SURRY POWER STATION UNIT NO. 1

AMENDMENT TO FACILITY OPERATING LICENSE

Amendment No. 42
License No. DPR-32

SUPPORTING AMENDMENTS NOS. 42 AND 41 TO LICENSE NOS. DPR-32 AND DPR-37

FIGURE 3.12-1A CONTROL BANK INSERTION LIMITS FOR 3-LOOP NORMAL OPERATION-UNIT 1

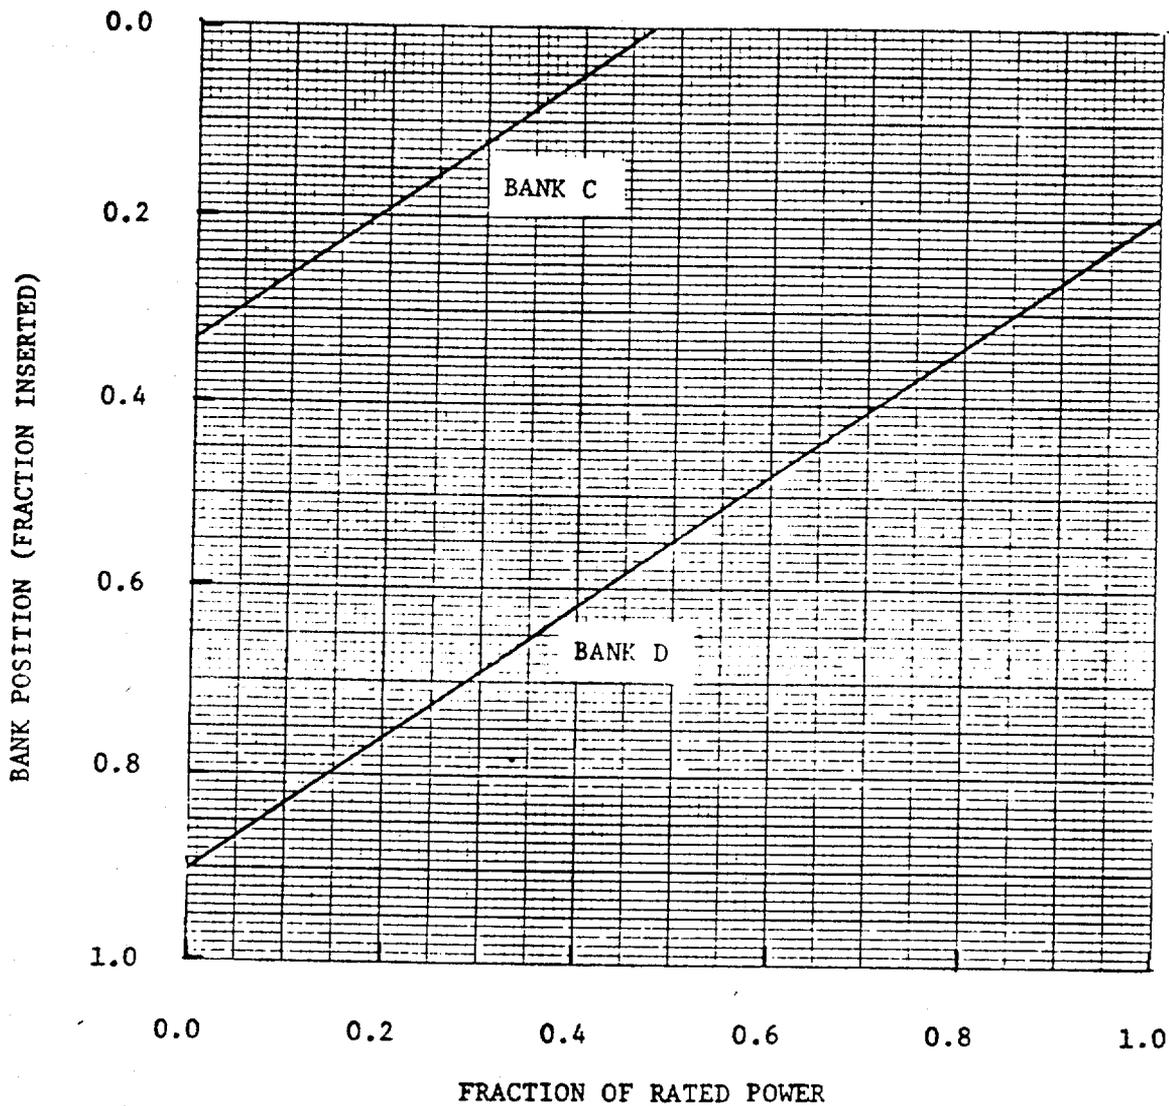
- 1) Reduce the axial flux difference operating band from +6 to -9% to +5%.
- 2) Revise the table of Design Condition Axial Peaking Factors, $F_z(Z)$ vs Core Height.
- 3) Revise the power dependent control rod insertion limits.

VEPCO has proposed to raise the control rod insertion limits to provide adequate margin to the $F_{\Delta H}$ limits. There are a number of criteria which the control rod insertion limits are checked against each cycle. The most important of these are shutdown margin, ejected control rod worth, and $F_{\Delta H}$. VEPCO found the latter to be the most restrictive for Cycle 5 operation and the insertion limits are proposed to be adjusted accordingly. We find the proposed control rod insertion limit Technical Specification change acceptable.

<u>Remove Pages</u>	<u>Insert Pages</u>
3.12-5	3.12-5
3.12-13	3.12-13
3.12-20	3.12-20
TS Table 3.12-1A	TS Table 3.12-1A
TS Figure 3.12-1A	TS Figure 3.12-1A
